Serial No.: 10/801,307

IN THE DRAWINGS

Amendments To Drawing Figures

REMARKS

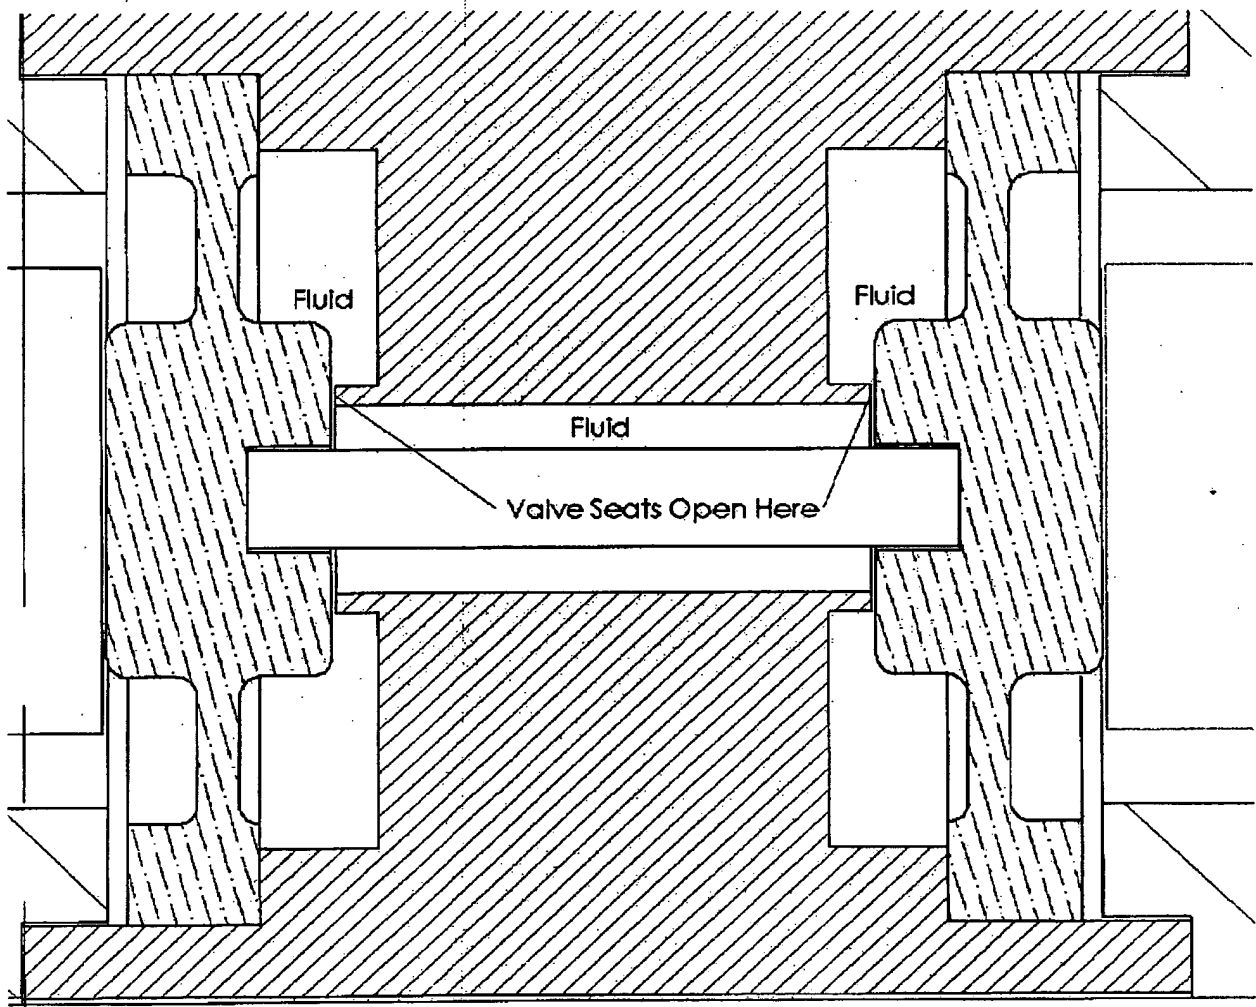
The drawings are also objected to for not illustrating various features of the claims, specifically the first position, second position and default neutral position. This rejection is respectfully traversed. 37 CFR 1.81 makes clear that drawings are required only where necessary for the understanding of the subject matter sought to be patented, which is not the case for the claimed subject matter pointed out in the Office Action.

Furthermore, in Fig. 11, the valve seats, which are mechanically interlocked with a small ceramic stem as described in conjunction with Figs. 2-8, are illustrated in the default neutral state wherein both valve seats of the three-way valve are open. This can be readily seen from the expanded and annotated view of Fig. 11 below:

FIG 2 (Prior Art)

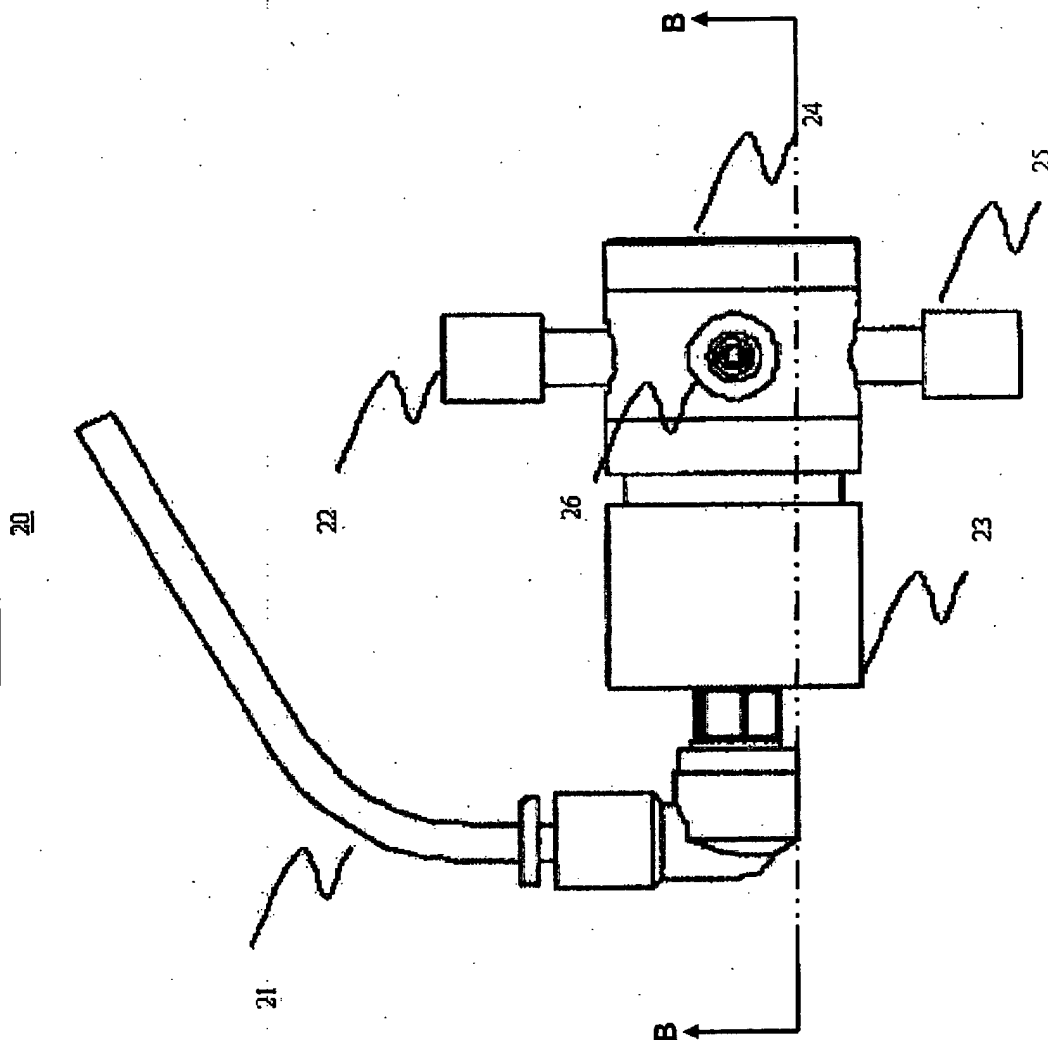
Figs. 2-8 have been amended to include "prior art" labels as requested in the Office Action. Replacement and marked-up (annotated) sheets are attached.

Figs. 1-8 are objected to as not providing the label "Prior Art." This has been done for Figs. 2-8. Fig. 1, however, is not prior art and thus has not been modified.

FIG 9

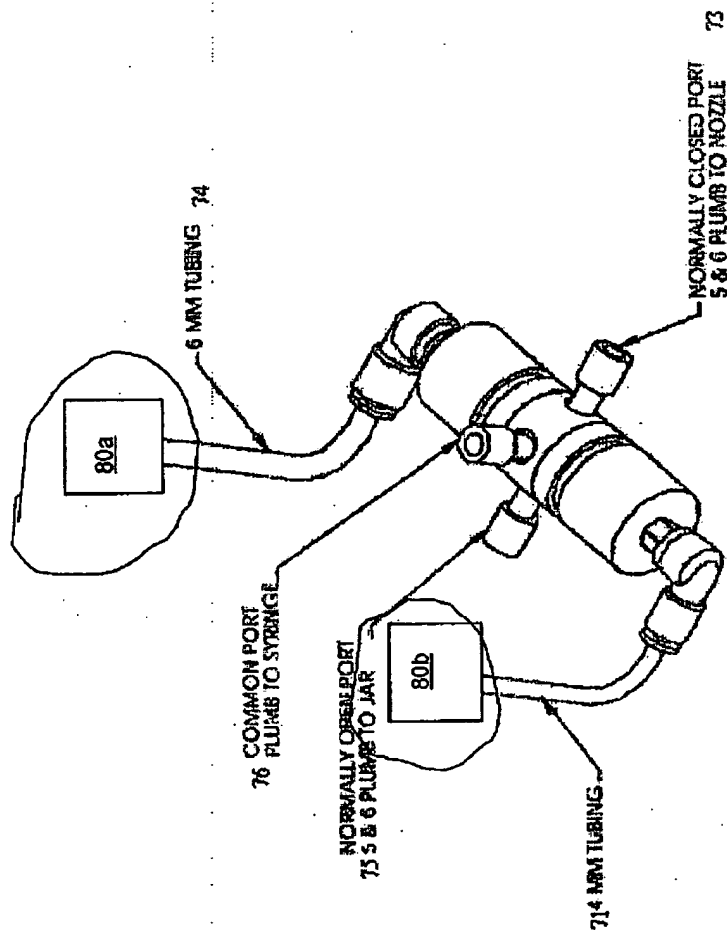
Fig. 9 has been amended to schematically illustrate supply pressure sources as requested in the Office Action. Replacement and marked-up (annotated) sheets are attached. The drawing modifications are a schematic depiction of what is described in the specification. No new matter is added.
